**PLANNING COMMISISON
SITE PLAN WAIVER REQUEST REVIEW SHEET**

CASE NUMBER:	SP-2018-0186C	PC HEARING DATE: Feb. 12, 2019
PROJECT NAME:	Office at Oak Springs	
ADDRESS:	3313 Oak Springs Drive	
COUNCIL DISTRICT #:	3	
OWNER/APPLICANT:	3133 Oak Springs, LLC (Chris Krager) 916 Springdale Road Bldg #5, Ste. 101 Austin, TX 78702	(512) 374-0946
ENGINEER:	Southwest Engineers, Inc. 205 Cimarron Park Loop, Ste B Buda, TX 78610	(512) 312-4336
CASE MANAGER:	Rosemary Avila Rosemary.avila@austintexas.gov	(512) 974-2784

CASE#: SP-2018-0186C
 ADDRESS: 3313 Oak Springs Drive
 CASE NAME: Office at Oak Springs
 MANAGER: Rosemary Avila

SITE & DIMENSION CONTROL PLAN

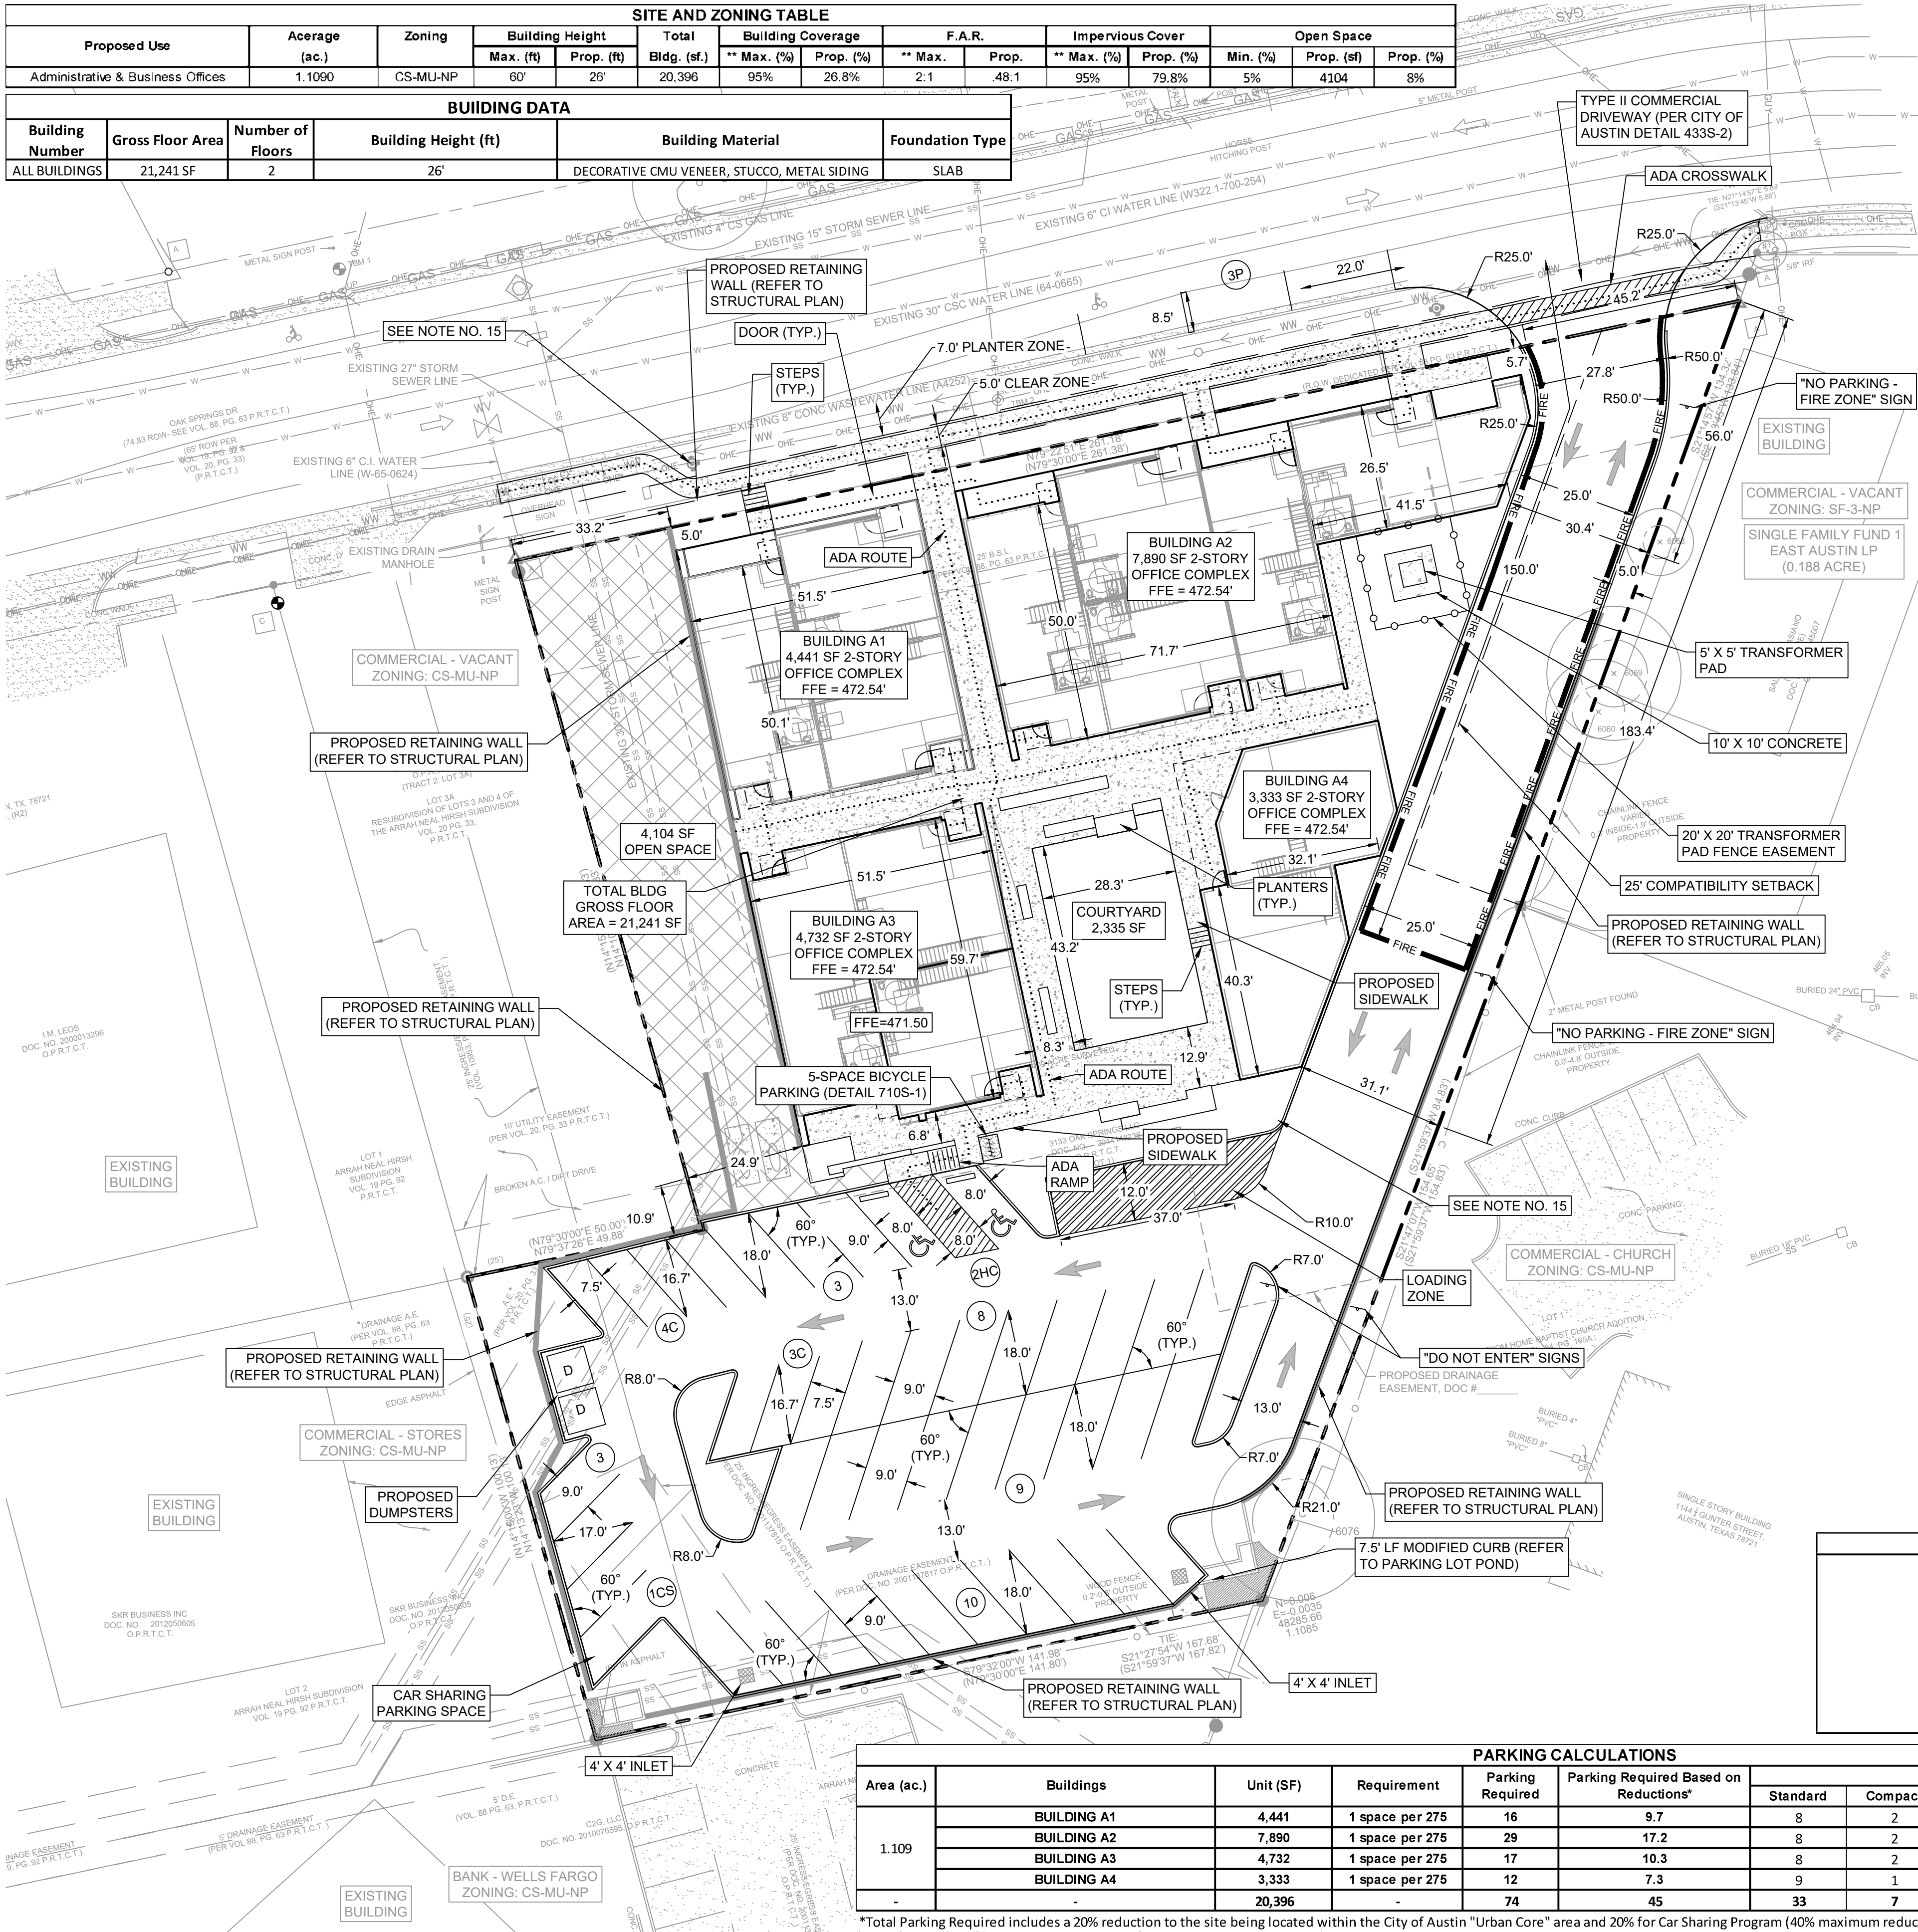
The applicant is requesting a waiver from § 25-2-1064 and § 25-2-1067(G). The site is subject to a 25' compatibility setback on the east property line and subject to a front setback of 25'. The proposed development is encroaching into the front setback for the building and side compatibility setback for the driveway. The proposed building is located 5' from the R.O.W. and the proposed driveway is located 5' from the eastern property line.

1. SP4 – Reduction of the 25' setback to the east edge of the property to 5' in order to construct our entry drive in this location (25-2-1067).
2. SP10 – Reduction of the required front yard setback per (25-2-1064) from 25' to 5'.

Staff recommends approval of the two waivers requested. The site has drainage constraints in the rear of the lot, which makes moving the building to the front of the lot a practical design decision. The LDC Compatibility Standards supersede the LDC Subchapter E: Design Standards. If this site wasn't located directly adjacent to a single family residence the applicant would have to build the site according to Urban Roadway standards (Subchapter E- 2.23) which requires the building to be built to up to the sidewalk. The site complies with all other compatibility standard requirements, such as lighting, screening, and building heights. All the exterior lighting will be hooded or shielded from the view of the adjacent single family property. The plans call out a vegetative buffer along the east property line for screening. The zoning allowance for the CS base district zoning is 60 feet. Due to this site being subject to compatibility standards the height allowance Office uses are considered an appropriate zone between the Airport Blvd corridor and the residential area.
